20007979-2	THERMAL BAR, RIGHT
20007979-1	THERMAL BAR, LEFT

THERMAL BAR, STAGE 1-2  
HORZ ACTUATOR  
LIGO-D047979-B

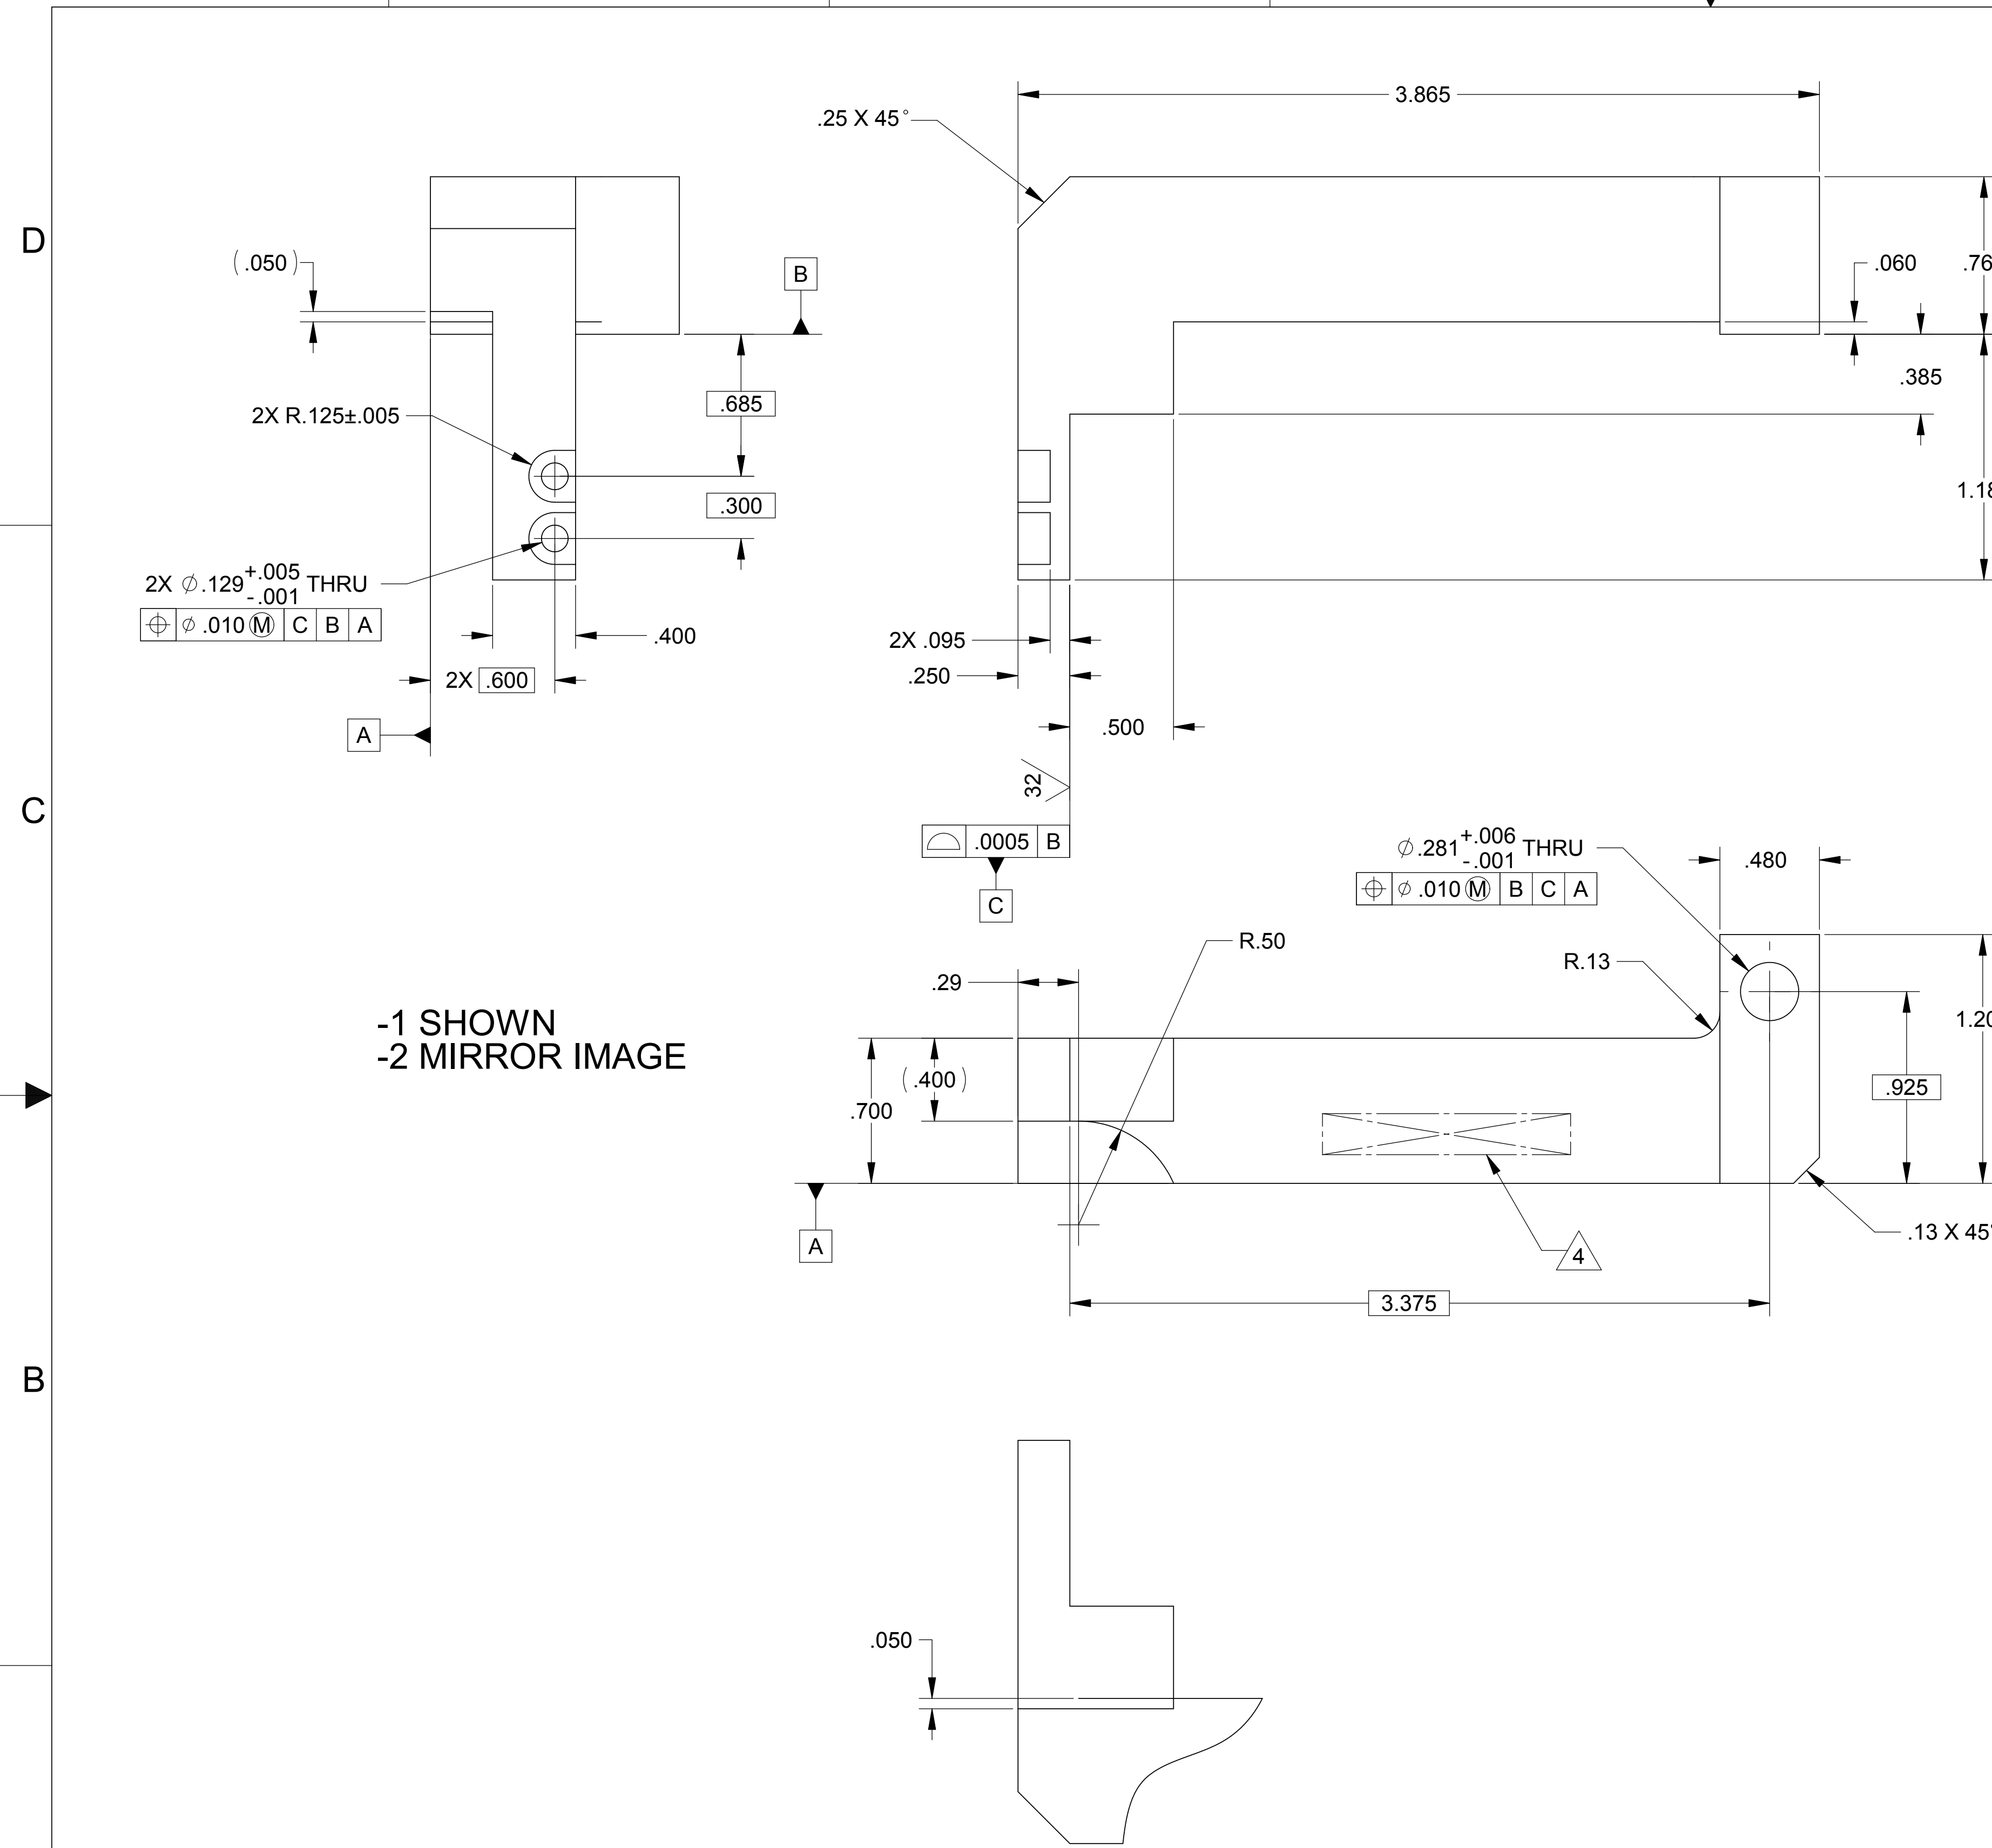
LTR		ZONE	DESCRIPTION	REVISIONS									
A			INITIAL RELEASE	DWN	CHK	PROJ ENGR	STRESS	MATL	CONFIG ENGR	ME	PROJ	QA	RELEASE DATE
B	C6		CHANGED C'BORE REMAINING THICKNESS: WAS 2X .115, IS 2X 0.095	RB	RF	KS	DCW	DCW	RF	RK	SV	GDL	1-24-05
				RF
